EDMS NO. <b>1439028</b>	REV. <b>1.0</b>	VALIDITY <b>RELEASED</b>
----------------------------	--------------------	-----------------------------

REFERENCE <b>LHC-BGV-EC-0003</b>
-------------------------------------

**ENGINEERING CHANGE REQUEST**

**Detector Cooling for the BGV Demonstrator in the LHC**

Figure 3: Proposed location of the chiller unit and path of the transfer line between UA43 and RA43.

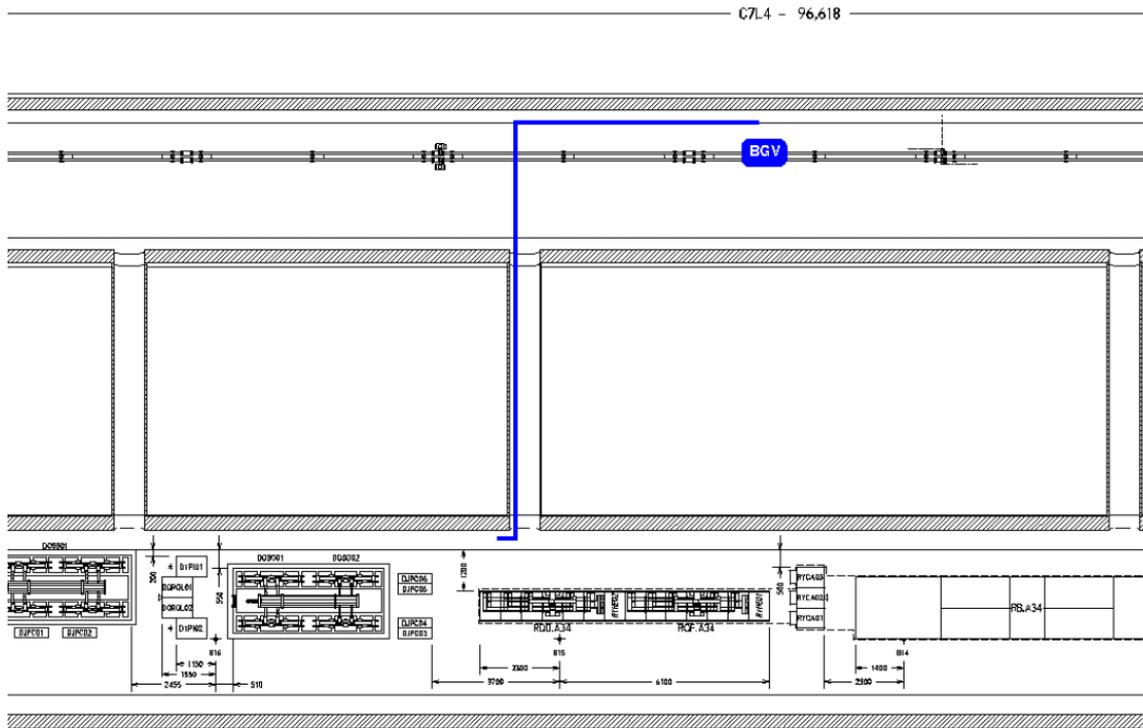
**Chiller integration:** given the significant power dissipation in the transfer line, it is essential to locate the chiller as close as possible to the detector. An integration study was performed by EN-MEF-INT to identify a possible location for the chiller unit and routing of the transfer line. Figures Figure 3, Figure 4, Figure 5 and Figure 6 show preliminary integration views of the proposed installation. The length of the cooling transfer line is about 20 m. This line will not constrain the space reserved for transport more than the currently existing systems in this region (cables, general and safety services). Concerning the patch panel, there is no interference nor trouble to access the adjacent VPIC pumping device

Figure 4: Proposed location of the cooling unit in UA43. The cooling unit is shown in grey and the transfer line in pink.

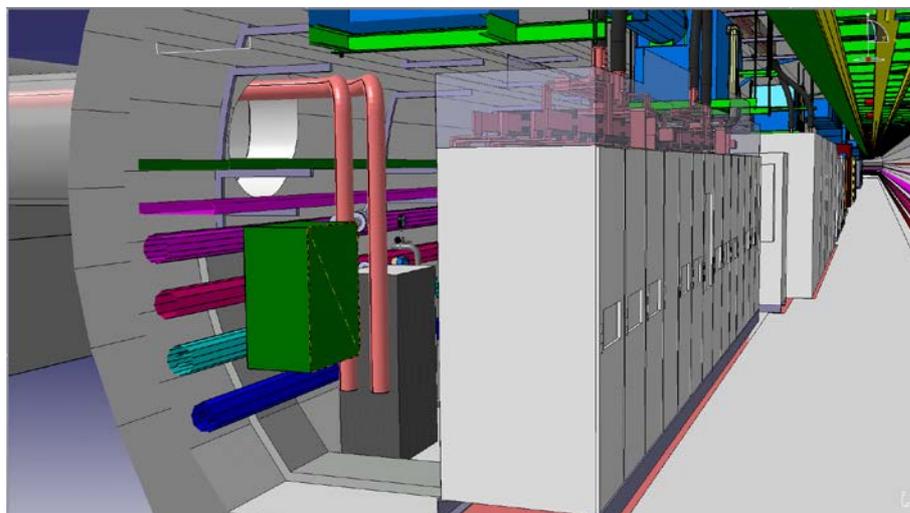
The dimensions of the Julabo chiller unit are: width = 430 mm, depth = 650 mm, height = 1260 mm. It is an air cooled device with maximal power dissipation of 3 kW.

Figure 5: Routing of the cooling transfer line (Preliminary).

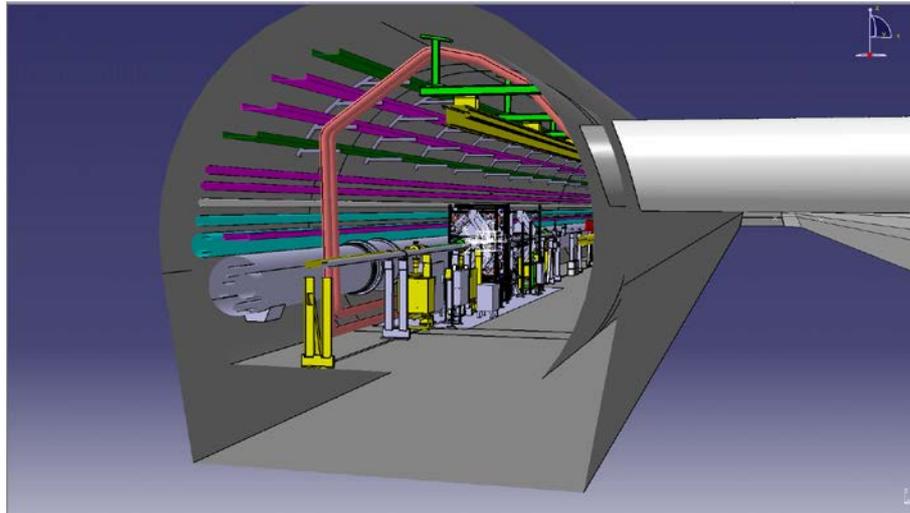
**Transfer lines:** Silicone tubes with ID/OD 16/22 mm.

Insulation - double layer Armaflex:

- Inside: LTD (cryo) type, 25 mm thickness
- Outside: NH (halogen free) type, 25 mm thickness.

This insulation is sufficient to avoid condensation. Further increase of the insulation thickness has little effect on the power dissipation. The expected power dissipation, based on a simulation performed by EN-CV-DC, is 10 W/m for cooling liquid temperature of  $-60\text{ }^{\circ}\text{C}$ .

Figure 7: Left: manifold for the distribution of the cooling liquid to the BGV modules. Right: view of detector modules around the beam pipe (in cyan) with the cooling tube connections (in grey).

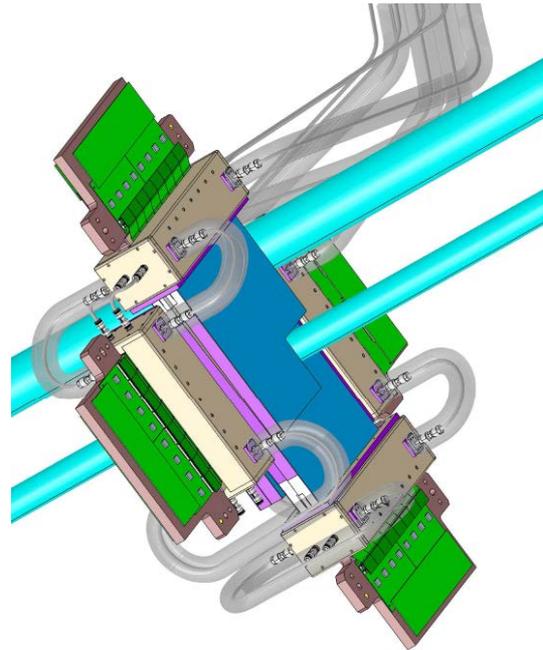
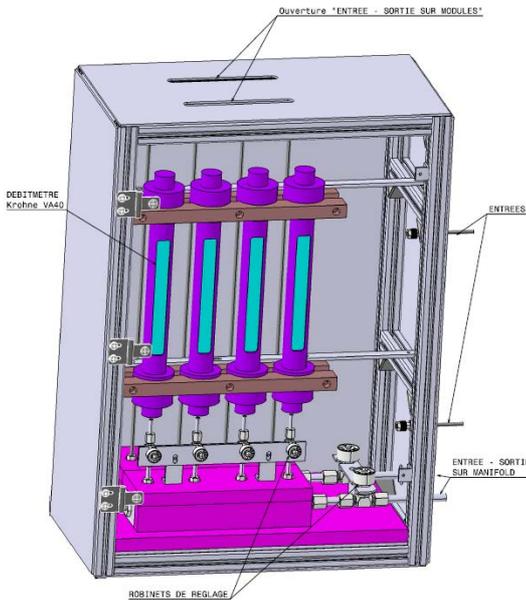
**Distribution to the detector modules:** a manifold will be used to distribute the cooling liquid to the individual detector modules (see Figure 7). The intention is to use 4 parallel distribution lines, each supplying 4 module halves connected in series. The distribution lines will use the same material as the transfer lines. A development version of the connection tubes routing is shown in Figure 7.
